Product Change Notice (PCN)

PCN Number: PCN-0454830R-01

SJ2-35813A-SMT-TR, SJ2-35813B-SMT-TR

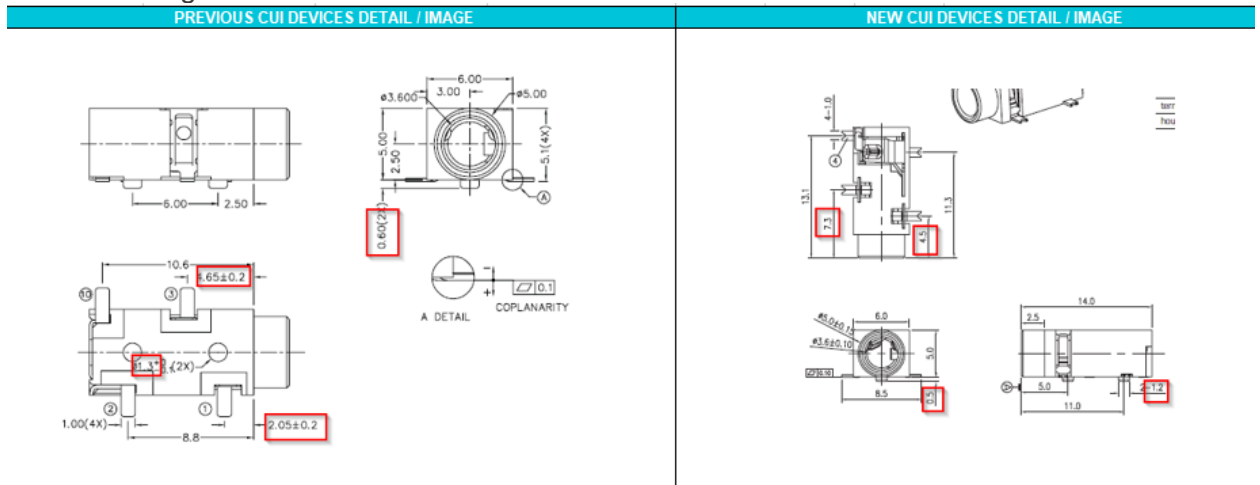
1. Minor Housing differences

2. PCB Layout differs

PREVIOUS CUI DEVICES DETAIL / IMAGE	NEW CUI DEVICES DETAIL / IMAGE
	<p>Recommended PCB Layout Top View</p>

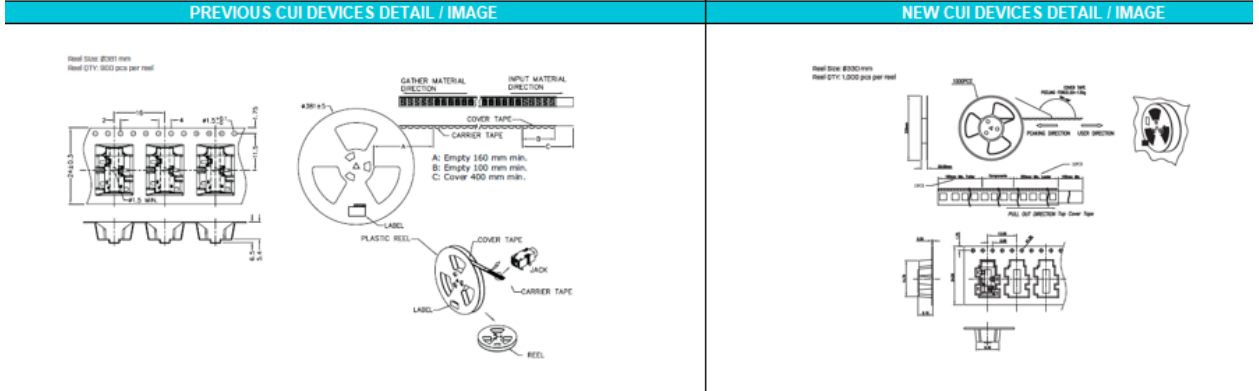
4. Reflow Soldering Difference

PREVIOUS CUI DEVICES DETAIL / IMAGE	NEW CUI DEVICES DETAIL / IMAGE																																				
<p>SOLDERABILITY</p> <table border="1"> <thead> <tr> <th>parameter</th> <th>conditions/description</th> <th>min</th> <th>typ</th> <th>max</th> <th>units</th> </tr> </thead> <tbody> <tr> <td>refl storage</td> <td>at relative humidity <80%</td> <td></td> <td></td> <td>40</td> <td>°C</td> </tr> <tr> <td>reflow soldering¹</td> <td>see reflow profile</td> <td>255</td> <td>260</td> <td>265</td> <td>°C</td> </tr> </tbody> </table> <p>drying conditions² parts in reel: bake at 40°C ±5°C for 72 hours parts removed from reel: bake at 40°C ±5°C for 10 hours</p> <p>Notes: 3. Must reflow solder within 72 hours from opening vacuum packaging at a temperature <130°C & relative humidity <60%. 4. When exceeding four life by >72 hours.</p>	parameter	conditions/description	min	typ	max	units	refl storage	at relative humidity <80%			40	°C	reflow soldering ¹	see reflow profile	255	260	265	°C	<p>SOLDERABILITY</p> <table border="1"> <thead> <tr> <th>parameter</th> <th>conditions/description</th> <th>min</th> <th>typ</th> <th>max</th> <th>units</th> </tr> </thead> <tbody> <tr> <td>refl storage</td> <td>5-25°C, 20-75% humidity</td> <td></td> <td></td> <td></td> <td></td> </tr> <tr> <td>reflow soldering</td> <td>see reflow profile</td> <td>255</td> <td>260</td> <td></td> <td>°C</td> </tr> </tbody> </table> <p>Notes: 1. CUI Devices recommends usage of the product within 24 hours after 130° is opened. After 24 hours, CUI Devices recommends drying the parts prior to use.</p>	parameter	conditions/description	min	typ	max	units	refl storage	5-25°C, 20-75% humidity					reflow soldering	see reflow profile	255	260		°C
